N4010A-04

S E R V I C E N O T E

N4010A Wireless Connectivity Test Set

Damaged Line Module Causes Instrument To Intermittently Re-boot

Figure 1: Line Module Connector (Attached To The Deck Assembly)

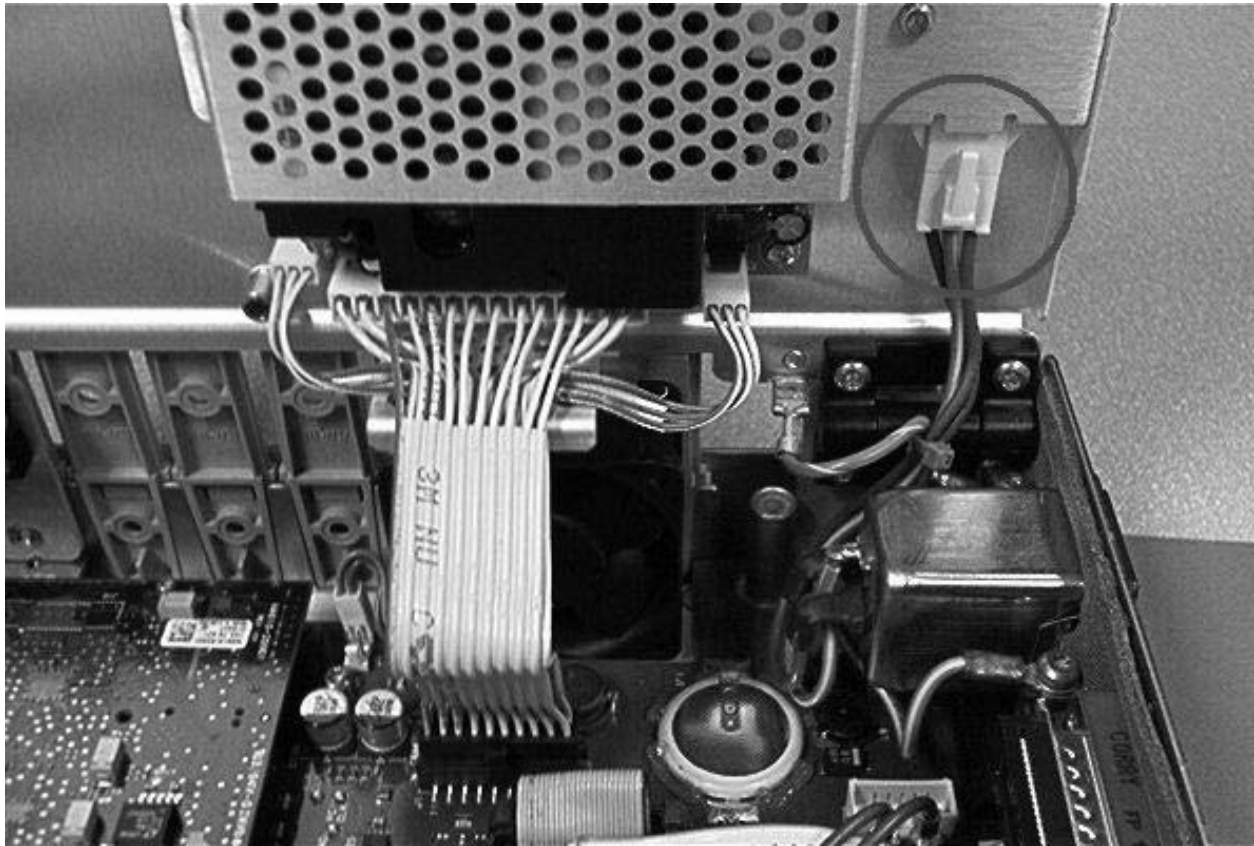
1. Ensure the instrument is not connected to a mains power supply.
2. Loosen the five captive screws on the bottom of the instrument.
3. Remove the top cover from the instrument.
4. [Option 102/103 units only] Disconnect the semi-rigid cables from ports 2 & 3 of the RF Switch.
5. Lift the hinged deck assembly into the vertical position.
6. Disconnect the white line module connector from the deck assembly (refer to Figure 1).
7. Inspect the terminals of the white line module connector for signs of damage (refer to Figures 2 and 3).

Figure 3: Example – Damaged Connector

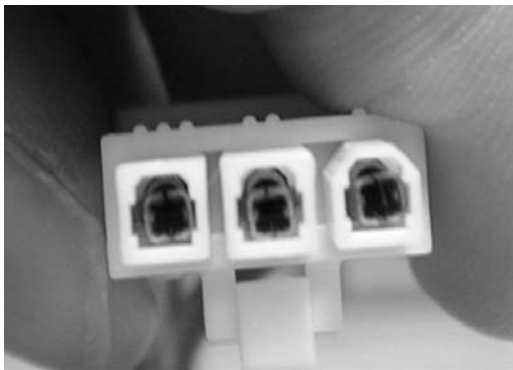
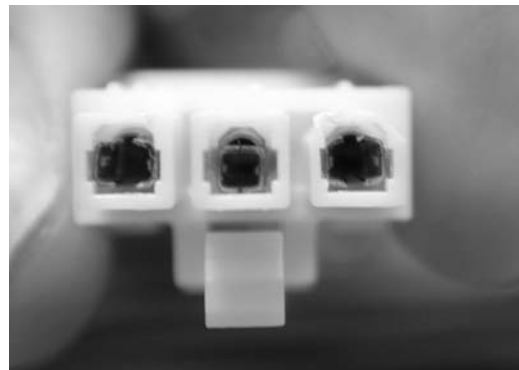
A manufacturing defect has resulted in damage to the line module of some N4010A instruments. The outer terminals (live and neutral) of a connector inside the N4010A have been forced open, which can cause an intermittent connection with the mating connector on the power supply unit. The center terminal (earth) of the line module connector is unaffected.

If the line module is damaged, it must be replaced. Once the instrument has been re-assembled, it must be tested to ensure it meets electrical safety requirements.
